Certified Action of the City of Raleigh Planning Commission

Case File / Name: SP-56-13 / Walgreens - Perry Creek

Site Plan

Staff Report

SP-56-13 / Walgreens – Perry Creek Road

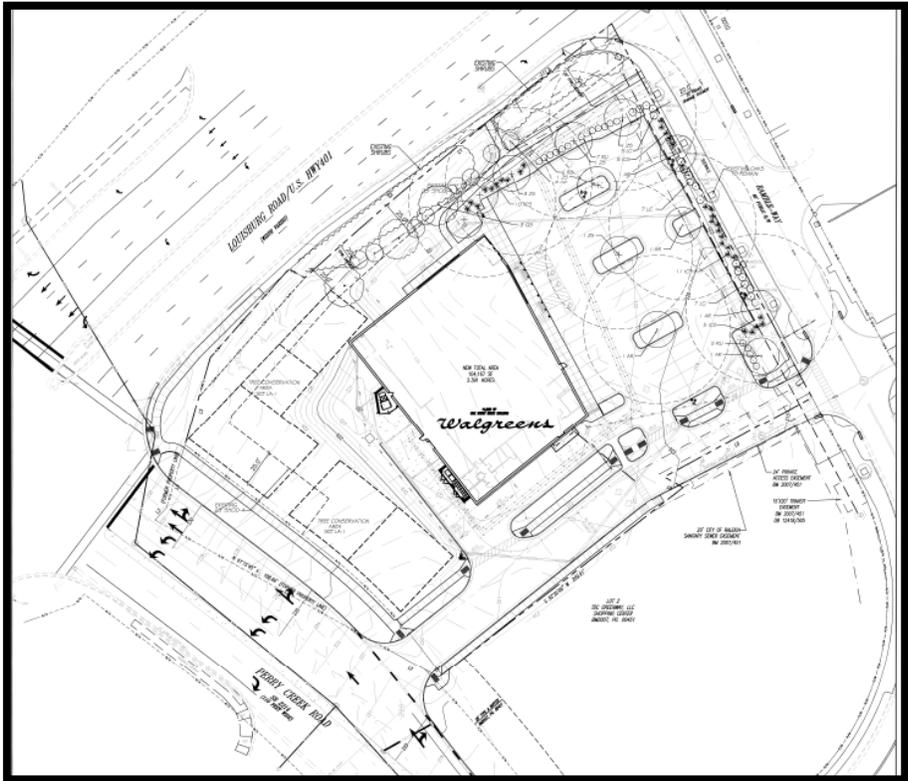
- (2) The final tree conservation plan will need to clarify that the tree conservation area boundary along Louisburg Road does not overlap with the Duke Energy easement and this needs to be discussed with the City Forestry Specialist prior to submittal.

- (3) That a nitrogen offset payment be made to a qualifying mitigation bank;
- (4) That a stormwater control plan with a stormwater operations and maintenance manual and budget shall be revised/approved by the Stormwater Engineer in compliance with Part 10A Chapter 9 of the Unified Development Ordinance, including the designation of buffer areas and open space areas for stormwater purposes prior to grading or the approval of construction drawings whichever event comes first;

- (6) That NCDOT has approved infrastructure construction plans for the proposed construction in Louisburg Road. NCDOT has reviewed the infrastructure construction plans for proposed construction in Perry Creek Road, and the comments of NCDOT must be incorporated into the final infrastructure construction plans prior to City approval of the construction drawings;

- (9) That in accordance with Z-29-05(1) and Z -58-04(14) the cross access easement recorded in Book 11550 PG 1046 be revised to:
- (a) Replace Kahn Family LLC with TDC Greenway LLC (see DB15217 PG 741) and
 - (b) Include the parcel acquired by TDC Greenway LLC in Deed Book 15267 PG 2109.
 - (c) Include the connection to Perry Creek Road as part of the access easements
